# DART SERVICE INSTRUCTION

TO AMEND INSTALLATION INSTRUCTIONS IIN-D135-1027 REV. E  
AND INSTRUCTIONS FOR CONTINUED AIRWORTHINESS ICA-D135-1027 REV. 2  
OR LATER APPROVED REVISIONS

A	NEW ISSUE (REF ECR 366)		SAD	22.03.01
REV.	DESCRIPTION		BY	DATE
DESIGN	SAD			
DRAWN	SAD			
CHECKED	KPT	DRAWING NO.		
MFG. APPR.	N/A	DSI 9873	REV. A	
APPROVED	CP			
DE APPR.	DS <i>[Signature]</i>	TITLE		
DATE	22.03.01	CROSSTUBE STEP HOLES	SCALE	NTS

FIGURE 1

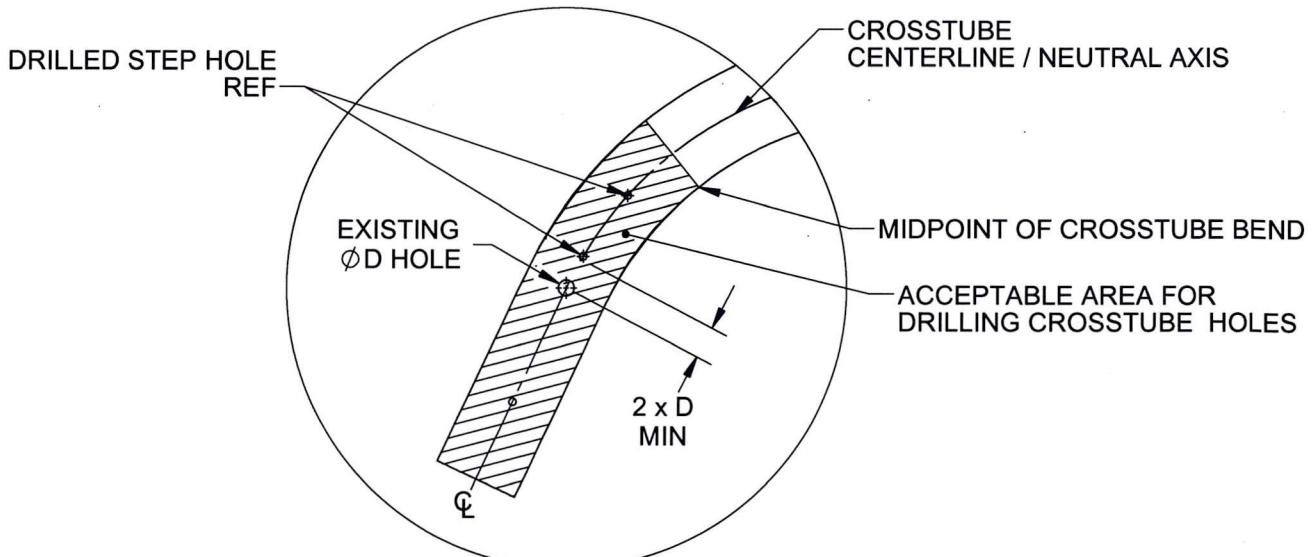
To ensure compatibility with a variety of step configurations, DART crosstube p/n D135-1027-101/-103/-141/-143/-201/-203/-241/-243 at CHG 003 (or later) and D135-1027-111/-113/-211/-213 at CHG 002 (or later) do not have pre-drilled step attachment holes.

It is acceptable to drill step attachment holes in DART D135-1027-XXX crosstubes using the following guidelines (see Figure 1 of this service instruction for reference):

- The drilled holes must be located on the centerline / neutral axis of the crosstube.
- The maximum size for the step holes is 0.625" (15.8mm).
- The drilled holes must be a minimum distance of  $2 \times$  diameter from any existing hole in the crosstube (measured from center of existing hole to edge of drilled hole).
- The holes must be drilled below the midpoint of the crosstube bend.
- Deburr all drilled holes and remove any debris from the inside of the crosstube. Touch up holes with chemical film material (Alodine 1200 or 1201) per MIL-DTL-5541.
